SDP-0610-01

STAFF REPORT

SUBJECT: Specific Design Plan SDP-0610-01
Type II Tree Conservation Plans TCPII-109-03-05 and TCPII-094-04-03
Oak Creek Club Phase 4
Landbays D, E and N

LANDBAY 'N'

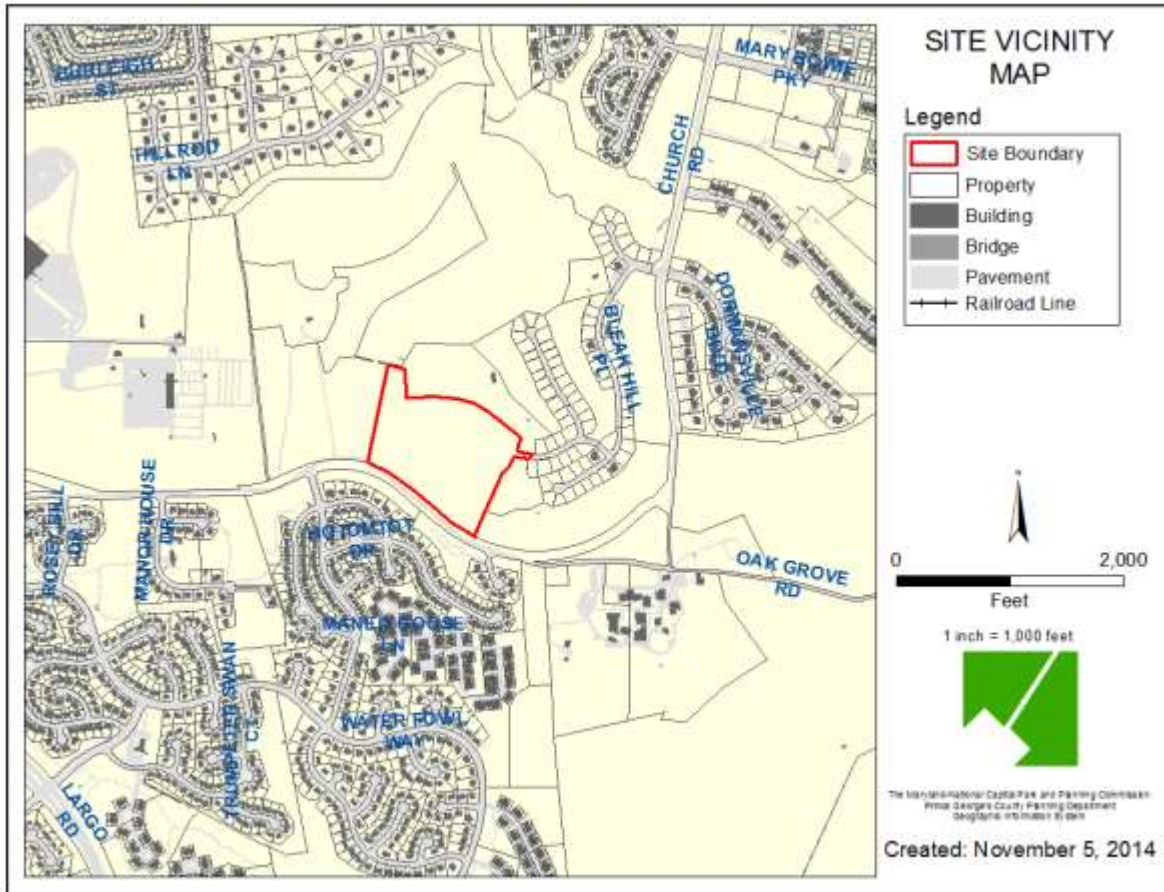
1. **Request:** The request in this case is to reconfigure Landbay 'N' so as to provide internal access to the 12 lots fronting on Oak Grove Road in Specific Design Plan SDP-0610, and provide a current approval that will supersede SDP-0610.
